RISO INC. **TECHNICAL INFORMATION BULLETIN**

Subject: Design Change "Separator" | Bulletin No: 42

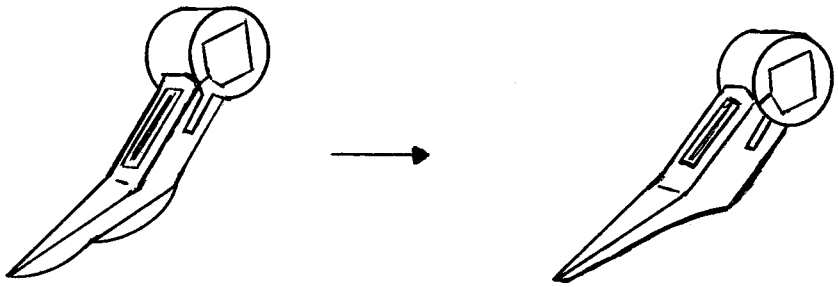
Purpose: The "Separator" Part # 007-13123 has been reshaped to reduce scratch marks in the center of the paper and also improves seperation.
